HYDROLOGY

K21/D14
TWO PLANS

GRADING & DRAINAGE PLAN

FACILITY FOR SOUTHWEST CHILDCARE
11800 LOMAS BOULEVARD NE
ALBUQUERQUE, N.M.

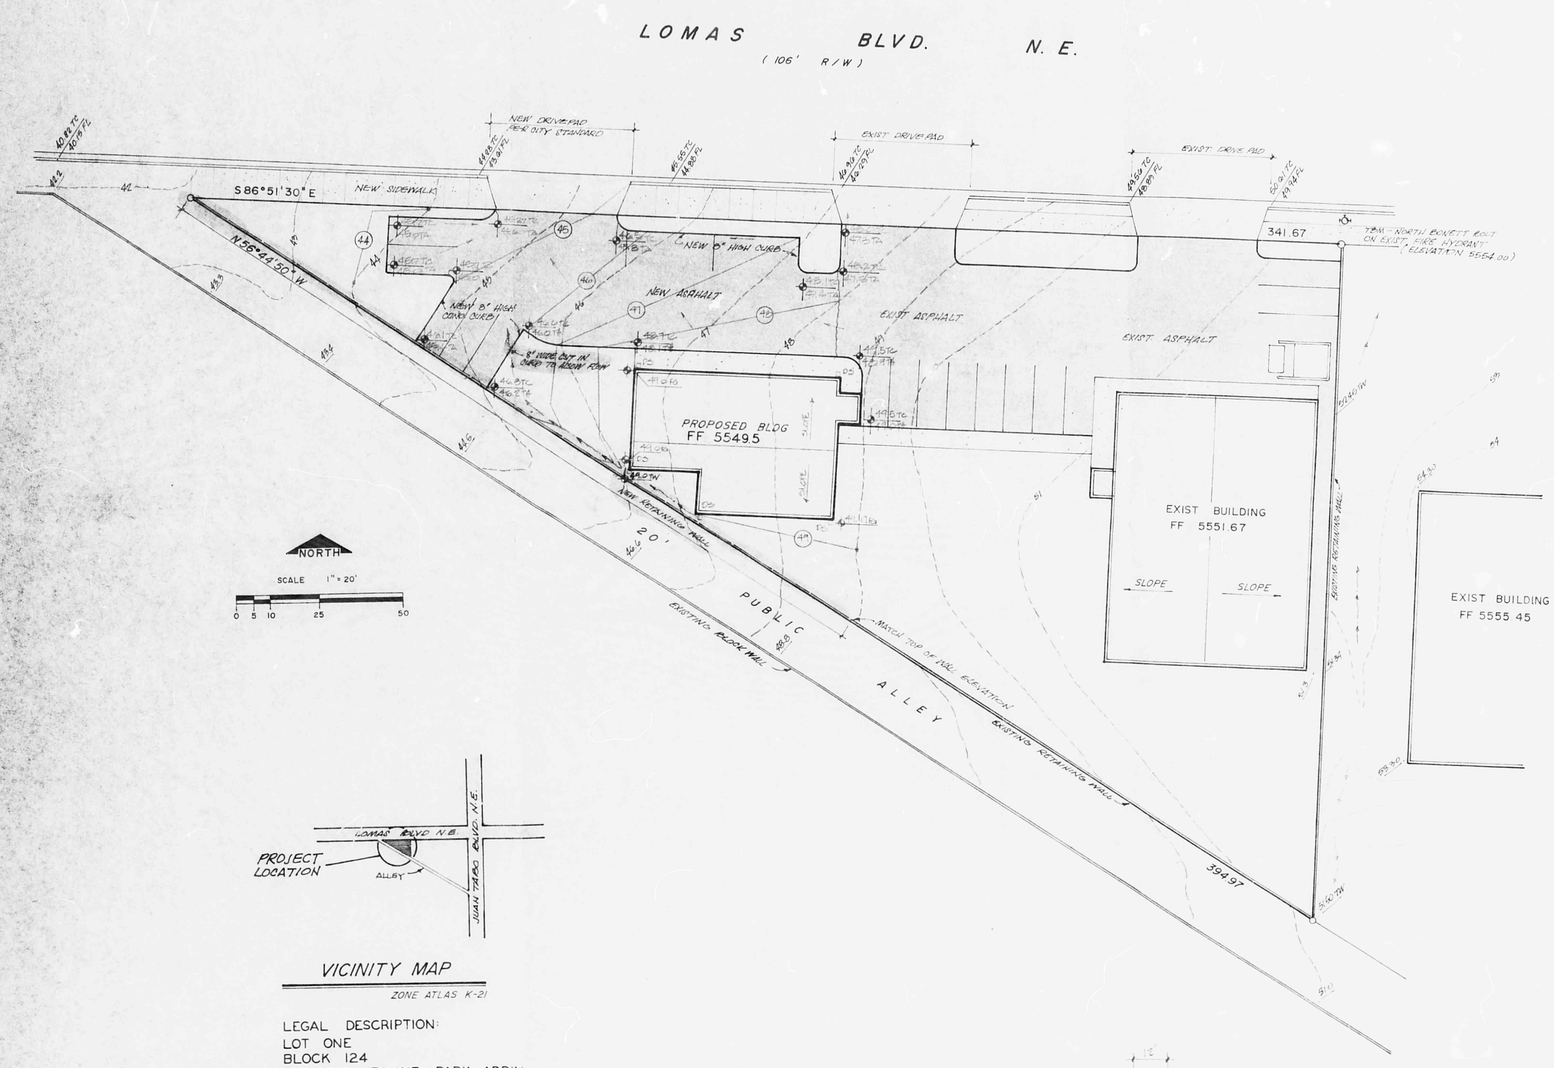
VOLUME CALCULATION BY SUB METHOD
MINOR CURVE CN = 61 (FIG A, PLATE 22.2, D-1)
CN OVERLAY (Commercial area to
PHASE AUTHOR Q, TABLE (FIG A, PLATE 22.2, D-4)
$Q = \frac{(P - 0.2S)^2}{P + 0.8S}$ (EQUATION 1-5)
P = 2.86 ——— Too High
S = (1000/CN - 10)
Q = 1.00 INCHES
TOTAL RUNOFF VOLUME
$\frac{1.00}{12} \times 33985 = 2833$ CU FT.

plate 22.2 D-3
% impervious = 52.7
Previous CN = 61
⇒ Composite CN = 81 not 92

52.7%
unimproved
